Assessment Officer Report - Salesian College (Mannix Campus), Chadstone

PA2402914, 2B Swanson Crescent
Chadstone VIC 3148

Officer Assessment Report
Development Approvals & Design

Figure 5: car park layout

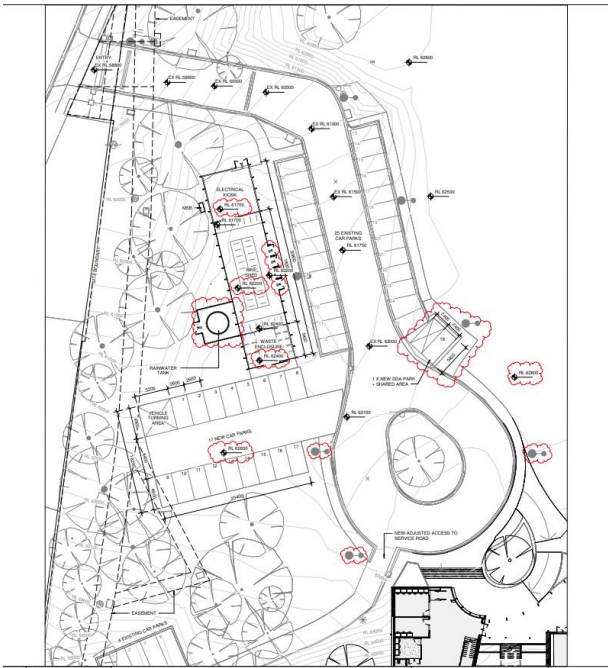
The design of the car parks and accessways are generally acceptable and accord with the Planning Scheme.

The bicycle shed is recommended to have electric charging facilities to cater for e-bicycles and e-scooters. The plans must indicate the number of bicycle parking spaces to be provided in the bike shed.

Figure 14: setbacks of the proposed buildings.

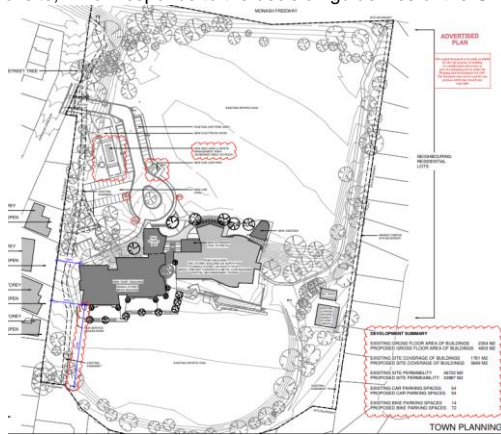
64. Due to the location of the proposed buildings deep within the site, the northern boundary setback is extensive. The proposed buildings have substantial setbacks from the side and rear boundaries. Specifically, the Year 7 building is setback 14.87 metres from the eastern boundary, and 52 metres from the southern boundary, see plan below.

66. In relation to overshadowing, the building setbacks are extensive and the shadow diagrams for 9 am – 5 pm, 22 September show that the shadow that would be cast from the proposed buildings are wholly contained within the school site.

Figure 21: car park changes

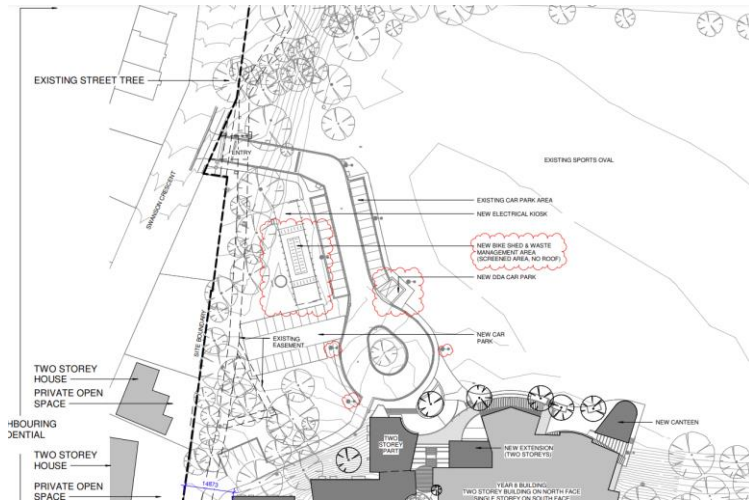
75. Similarly, the number of car parking spaces required by Clause 52.06 does not apply, however, this matter has been given consideration, noting that there will be some additional staff associated with the proposed school buildings.
76. A new car park area comprising 18 spaces (17 regular and one DDA) will replace 18 existing car spaces that are to be removed, meaning that the site will still have 54 car spaces. There is no net loss of car parking spaces as a result of this application. Car parking will appropriately remain accessible from the existing vehicular accessway, see image below:

78. Head of Transport Victoria has reviewed the application and provided no objection. Monash City Council has also reviewed the traffic report and plans and raised no concern or objection.
79. The council has noted that the specifications for the 28-seater Munro bus appear to indicate a length of 7.6m long which would meet council's Traffic Engineer's requirement for no buses longer than 10m. These details will be included as a permit condition to ensure that larger buses would not interrupt the surrounding residential streets. As such, the works to the car park can be supported.
